Final Precursor Analysis

Accident Sequence Precursor Program --- Office of Nuclear Regulatory Research

Fitzpatrick	Automatic Reactor Trip and Loss of Offsite Power Due to the August 14, 2003, Transmission Grid Blackout	
Event Date 8/14/2003	LER: 333/03-001	CCDP ¹ = 4×10^{-6}

December 17, 2004

Figure 1: Fitzpatrick LOOP event tree.

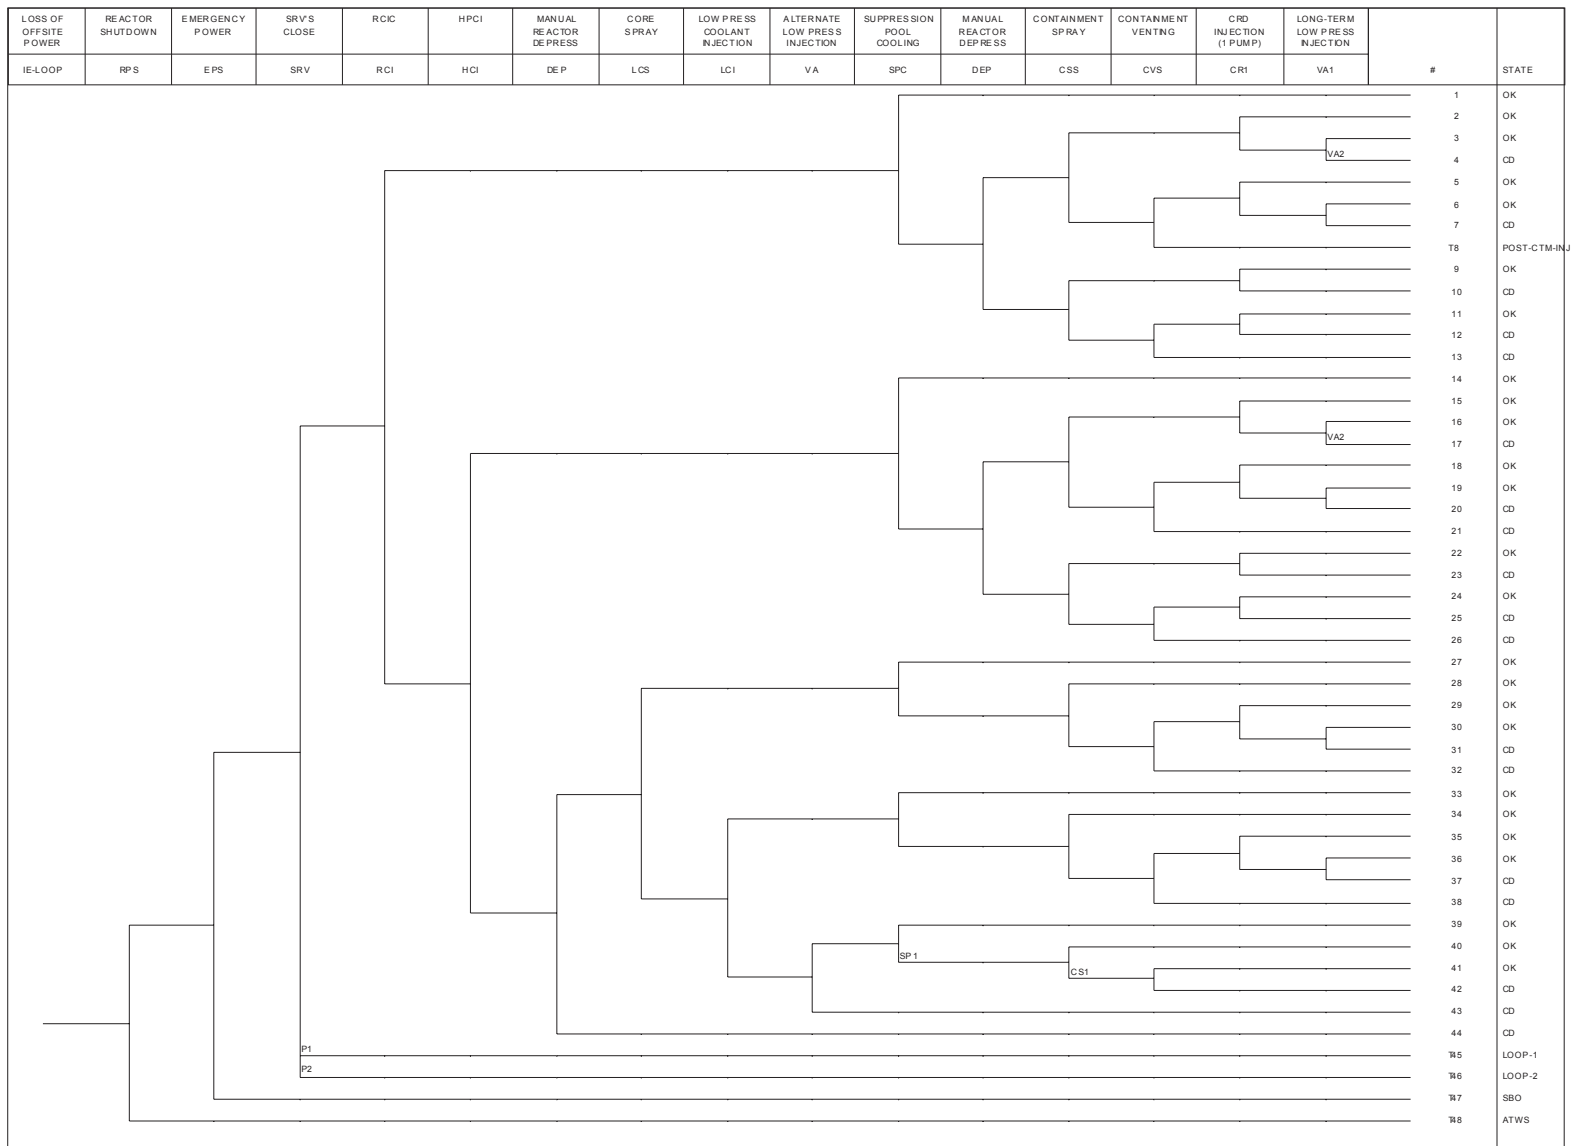
“The crosstie between the firewater system and EDG jacket coolers can be credited in accident sequence cutsets which involve failures of components in the ESW system with successful closure of 46MOV-102A/B. As an example, for the dominant core damage sequence LOOP/SBO sequence 47-02, fire water cross-tie recovery can be credited for cutsets of CCDP $6.5E-7$ and below.”

Response: The firewater backup is included for EDG cooling. For sequence 47-02, each cut set in the GEM report with CCDP below $6.5E-7$ contains the event FWS-XHE-ERROR. FWS-XHE-ERROR is defined as “operator fails to start/control firewater injection/cooling,” which is used for alternate injection and for EDG jacket cooling. The probability of FWS-XHE-ERROR is $6.0E-2$.
